India comments on EPPR-07-04e

MEASUREMENT PROCEDURE FOR [TWO- OR THREE-WHEELED LIGHT MOTOR VEHICLES]
EQUIPPED WITH A COMBUSTION ENGINE WITH REGARD TO THE CRANKCASE AND
EVAPORATIVE EMISSIONS

8th Session of EPPR
13th ó 15th October meeting
Beijing, China

Vapor temperature of various tanks - Concurrently measured

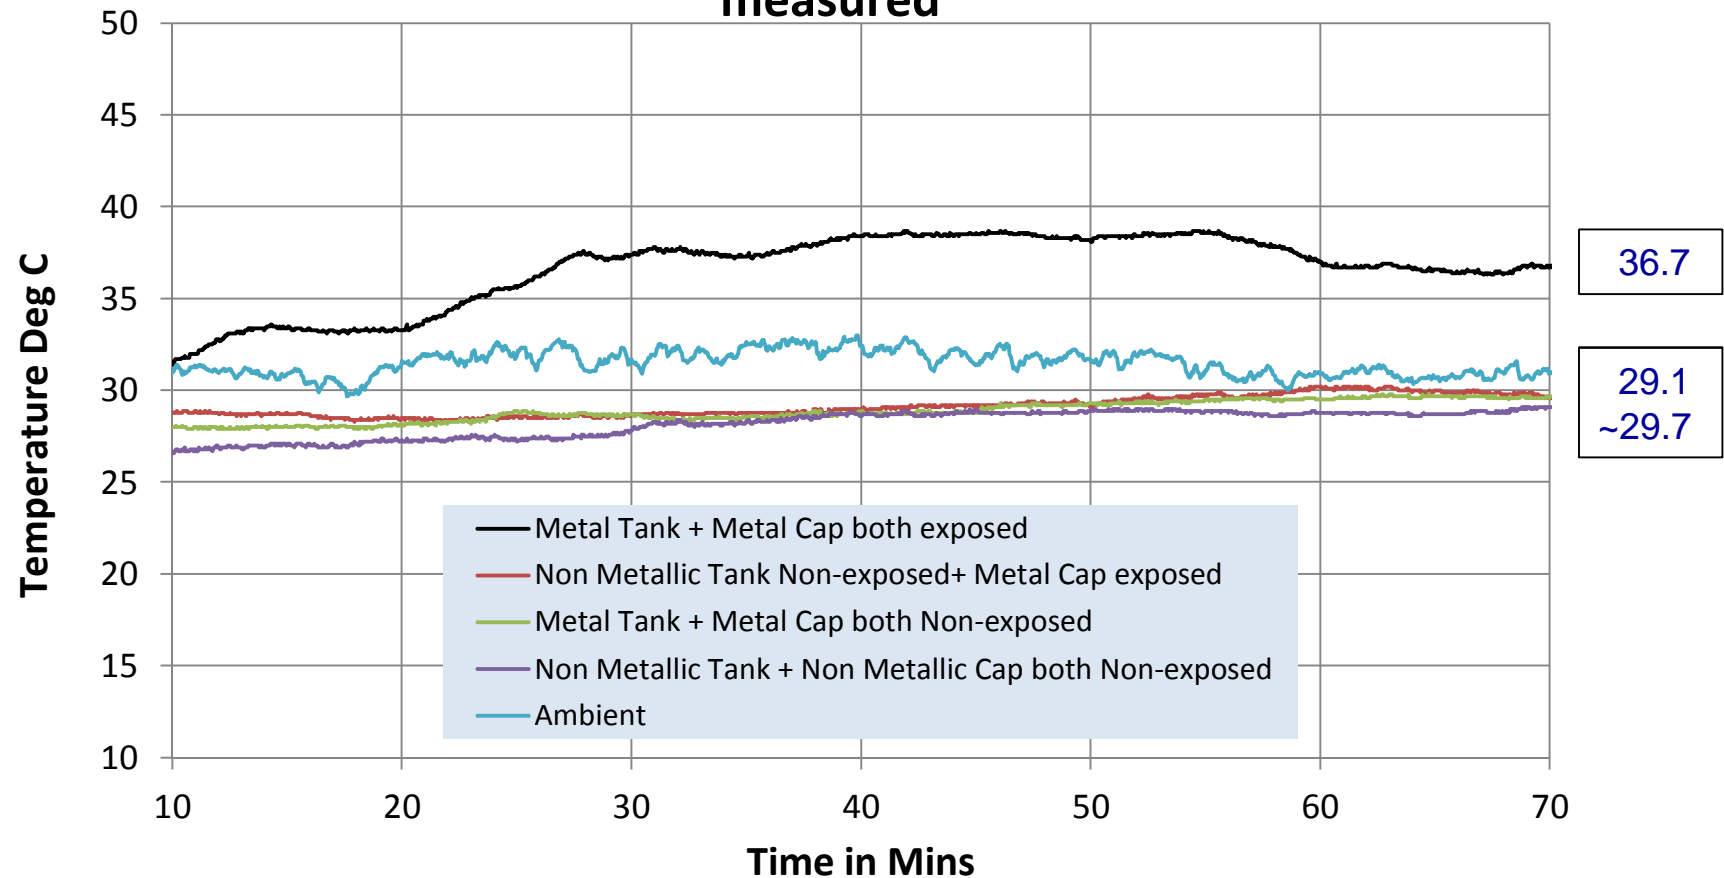
whether cap is exposed or not, vapor temperature of non exposed fuel tanks --
" Is of the same order.
" Is far below that with fully exposed tank.

- “ **Proposed definition**
 - . **‘Non exposed’ type of fuel storage tank and delivery system means that fuel storage and fuel delivery system, *except the fuel tank cap*, are not directly exposed to radiation of sunlight.**

Fuel temperature of various tanks - Concurrently measured

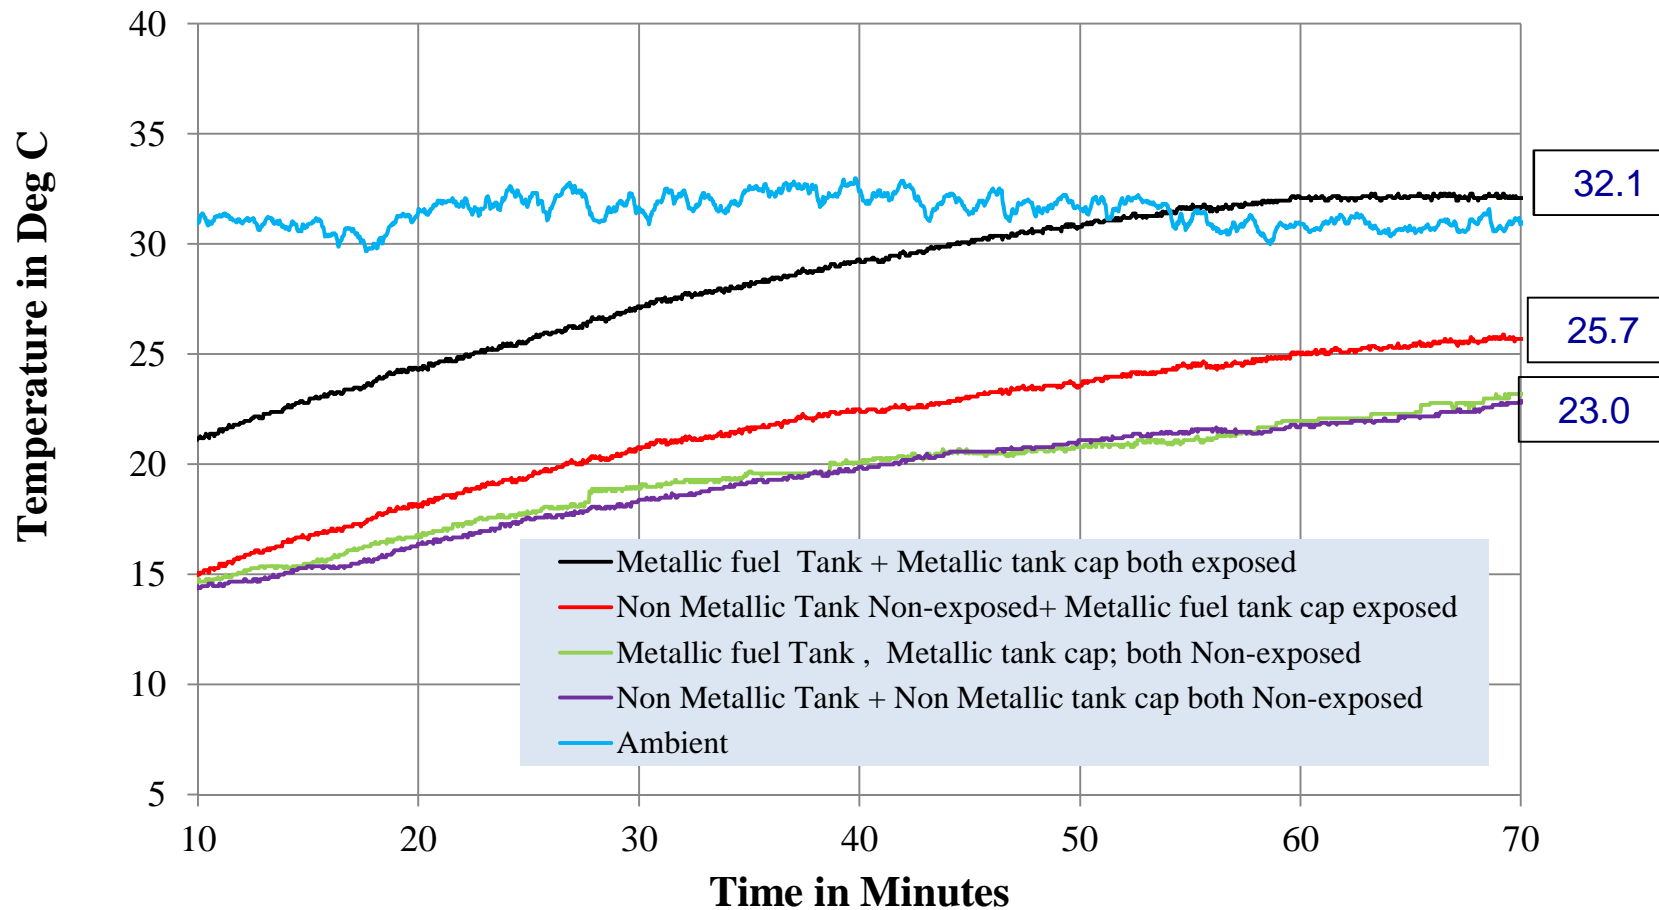
With cap exposed fuel temperature of non exposed fuel tanks

“ Is appx. 2.7 Deg.C rise

“ but is far below that with fully exposed tank.

“ Is very close to non exposed tank & cap.
